Item Name: Crosstube Assembly, Mid Fwd

DART AEROSPACE LTD HAWKESBURY, ONTARIO, CANADA	
DRAWING NO. D206-667-147	REV. A SHEET 1 OF 4
TITLE CROSSTUBE ASS'Y (206L MID FWD)	SCALE NTS
COPYRIGHT © 2010 BY DART AEROSPACE LTD THIS DOCUMENT IS PRIVATE AND CONFIDENTIAL AND IS SUPPLIED ON THE EXPRESS CONDITION THAT IT IS NOT TO BE USED FOR ANY PURPOSE OR COPIED OR COMMUNICATED TO ANY OTHER PERSON WITHOUT WRITTEN PERMISSION FROM DART AEROSPACE LTD.

DRAWING NO. D206-667-147	TITLE CROSSTUBE ASS'Y (206L MID FWD)	REV. A	DART AEROSPACE LTD ENGINEERING ORDER		D.E.O. NO. D206-667-147-A-1	SHEET NO. SHEET 1 OF 1	SCALE NTS
DRAWN <i>Q</i>	CHECKED <i>ASS</i>	MFG. APPR. <i>JB</i>	APPROVED <i>MD</i>		DE APPR. <i>MD</i>		
DATE 11.07.15	DATE 11.07.20	DATE 11.07.21	DATE 11/07/21		DATE 11.07.21

DRAWING NO. D206-667-147	TITLE CROSSTUBE ASS'Y (206L MID FWD)	REV. A	DART AEROSPACE LTD ENGINEERING ORDER		D.E.O. NO. D206-667-147-A-2	SHEET NO. SHEET 1 OF 1	SCALE NTS
DRAWN AJS	CHECKED	MFG. APPR. <i>BE</i>	APPROVED <i>AD</i>		DE APPR. <i>AD</i>		
DATE 12.08.02	DATE 12.08.02	DATE 12.08.02	DATE 12.08.02		DATE 12.08.02	DATE 12.08.02

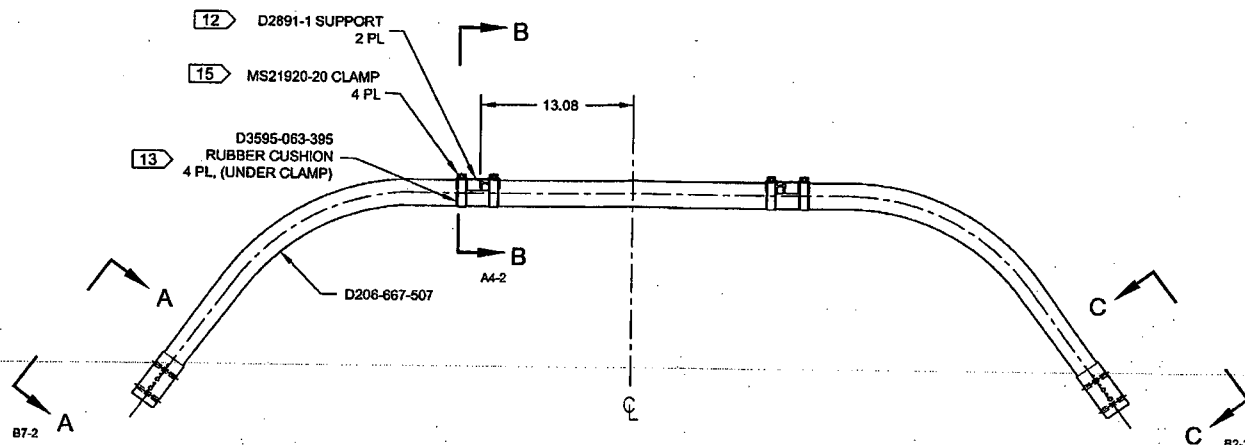
REPLACE MAGNOBOND WITH PROSEAL.

NOTE 12 & 15, SHEET 1 IS AMENDED AS FOLLOWS:

- 12) INSTALL D2891-1 SUPPORT USING 0.03" TO 0.06" THICK LAYER OF MAGNOBOND 6398 PER QSI 015. LET CURE FOR 12 HOURS AFTER INSTALLATION AND PRIOR TO PACKAGING.
- 15) TORQUE CLAMPS 80 TO 100 IN-LB. ENSURE AT LEAST 1.5 THREADS SHOWING IN SAFETY AND THAT NUT HAS NOT BOTTOMED-OUT AFTER TORQUING.

- 12) TO INSTALL D2891-1 SUPPORT: ABRABE MATING SURFACE OF SUPPORT AND CROSSTUBE WITH 180-GRIT SANDPAPER AND REMOVE RESIDUE WITH MEK (OR EQUIVALENT). APPLY A 0.04" TO 0.07" THICK LAYER OF PROSEAL 890 CLASS B-2 (OR AMS-S-8802 CLASS B-2) SEALANT TO MATING SURFACE OF SUPPORT.
- 15) TORQUE CLAMPS 80 TO 100 IN-LB. ENSURE AT LEAST 1.5 THREADS SHOWING IN SAFETY AND THAT NUT HAS NOT BOTTOMED-OUT AFTER TORQUING. **PRIOR TO PACKAGING, RE-CHECK TORQUE ON CLAMPS AFTER PROSEAL 890 SEALANT HAS CURED FOR 72 HOURS.**

DETAIL P
BONDING STRAP INSTALLATION 2 PL

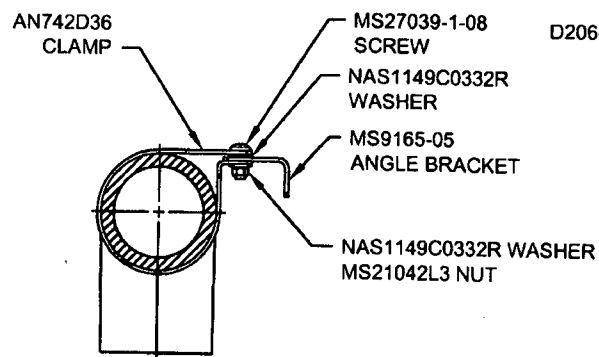
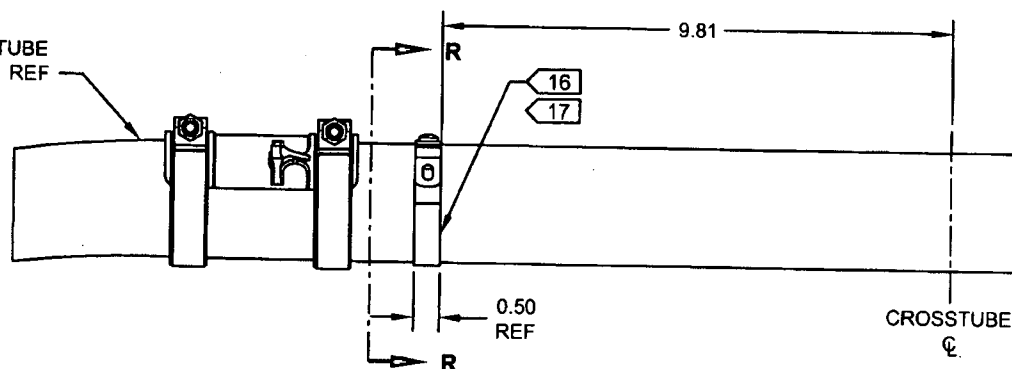
ADD ELECTRICAL GROUNDING STRAP

- 16) MASK AREA UNDER CLAMP PRIOR TO PAINTING
 - 17) SEAL EDGES WHERE AN742D36 CLAMP MEETS WITH THE CROSSTUBE USING SIKAFLEX-241/-291 OR MIL-S-8802 CLASS B2 OR PROSEAL 890 SEALANT
 - 18) PERFORM RESISTANCE CHECK TO ENSURE MAX RESISTANCE IS 10 MILLIOHMS
- AFT
